UNITED STATES PATENT AND TRADEMARK OFFICE

APPLICATION NO.	FILING DATE	FIRST NAMED INVENTOR	ATTORNEY DOCKET NO.	CONFIRMATION NO.
09/455,991	12/06/1999	HISASHI OHTANI	07977/213002	5835

**Office Action Summary**

## DETAILED ACTION

FIG. 8

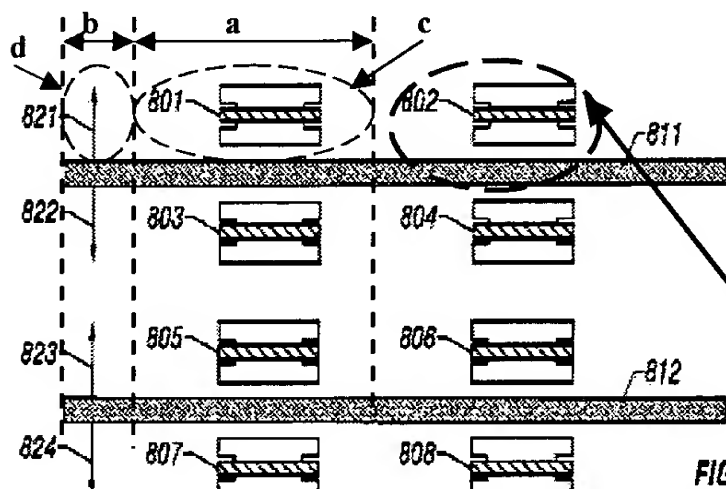
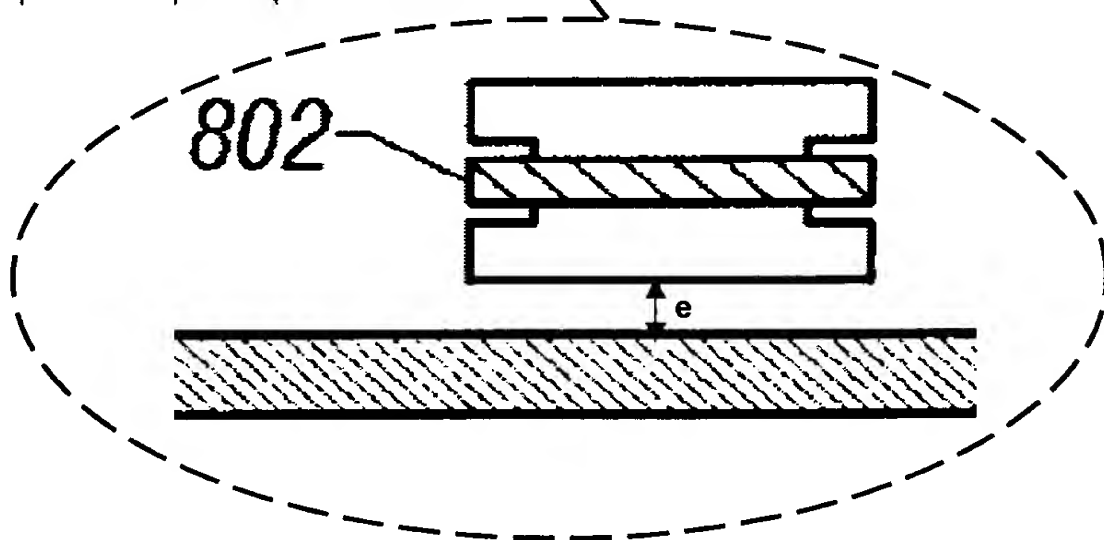
Regarding claim 6, Applicant acknowledges that is well known in the art a method comprising the steps of: forming an amorphous semiconductor film on an insulator surface (see "Description of the Related Art" and Figs. 1B and 8); providing a metal element (811, 812) capable of promoting crystallization of the amorphous

semiconductor film to form a first metal element added region (a) and a second metal element added region (b) (see Fig. 8, attached hereto); crystallizing the amorphous semiconductor film so that a crystal growth (821, 822, 823, 824) proceeds in a crystal growth direction parallel to the insulating surface to form first and second crystalline portion (c, d) (see Fig. 8, attached hereto); patterning the crystalline semiconductor film to form at least one crystalline island (801) using only the first crystalline portion (c) (see Fig. 8, attached hereto); wherein carrier move in the crystalline semiconductor island (801) in a carrier moving direction identical with the crystal growth direction (821) (see "Description of the Related Art" and Fig. 8); wherein the second metal element added region (b) is located apart from the crystalline semiconductor island (801) by a distance (e) (see Fig. 8, attached hereto); wherein the first metal element added region (a) has a length extending longer from an end portion of the crystalline semiconductor island (801) in a longitudinal direction of the first metal element added region (consider the portion of the metal element (811) that is between the end side of the region (b) and the end side of the crystalline semiconductor island (801)) (see Fig. 8, attached hereto).

Regarding claims 7, 32 and 56, Applicant acknowledges that the lengths of the first metal element added region (a) and the second element added region (b) are set to 50% or more of a crystal growth distance (e) (Compare the length of the distance (e) with the lengths of each region (a, b)).

Regarding claims 8, 25, 33, 41, 49, 57 and 65, Applicant acknowledges that the metal element comprises at least Ni (811) (see Fig. 8 and page 3, line 21 of Applicant's Specification).

Regarding claims 24 and 48, Applicant acknowledges that is well known in the art a method comprising the steps of: forming an amorphous semiconductor film on an insulator surface (see "Description of the Related Art" and Figs. 1B and 8); providing a metal element (811, 812) capable of promoting crystallization of the amorphous semiconductor film (see Fig. 8, attached hereto); crystallizing the amorphous semiconductor film so that a crystal growth (821, 822, 823, 824) proceeds in a crystal growth direction parallel to the insulating surface from a metal element added region (811, 812) (see Fig. 8, attached hereto); patterning the crystalline semiconductor film to form at least one crystalline island (801) (see Fig. 8, attached hereto); wherein the metal element added region (811, 812) has a length extending longer from an end portion of the crystalline semiconductor island (801) in a longitudinal direction of the metal element added region (811) (see Fig. 8, attached hereto).

Regarding claims 31, 39, 55 and 63, Applicant acknowledges that is well known in the art a method comprising the steps of: forming an amorphous semiconductor film on an insulator surface (see "Description of the Related Art" and Figs. 1B and 8); providing a metal element (811, 812) capable of promoting crystallization of the amorphous semiconductor film to at least two selected regions (c, d) of the amorphous semiconductor film (see Fig. 8, attached hereto); crystallizing the amorphous

semiconductor film so that a crystal growth (821, 822, 823, 824) proceeds in a crystal growth direction parallel to the insulating surface (see Fig. 8, attached hereto); patterning the crystalline semiconductor film to form at least one crystalline island (801) (see Fig. 8, attached hereto); wherein a portion (d) of the crystalline semiconductor film formed by using one metal element added region (811) is not used to form crystalline semiconductor islands (801) (see Fig. 8, attached hereto).

Regarding claims 40, 47, 64 and 71, Applicant acknowledges that is well known in the art a method comprising the steps of: forming an amorphous semiconductor film on an insulator surface (see "Description of the Related Art" and Figs. 1B and 8); providing a metal element (811, 812) capable of promoting crystallization of the amorphous semiconductor film to at least two selected regions (c, d) of the amorphous semiconductor film (see Fig. 8, attached hereto); crystallizing the amorphous semiconductor film so that a crystal growth (821, 822, 823, 824) proceeds in a crystal growth direction parallel to the insulating surface (see Fig. 8, attached hereto); patterning the crystalline semiconductor film to form at least one crystalline island (801) (see Fig. 8, attached hereto); wherein the metal element added region (811, 812) has a length extending longer from an end portion of the crystalline semiconductor island (801) in a longitudinal direction of the metal element added region (811) (see Fig. 8, attached hereto); and wherein a portion (d) of the crystalline semiconductor film formed by using one metal element added region (811) is not used to form crystalline semiconductor islands (801) (see Fig. 8, attached hereto).
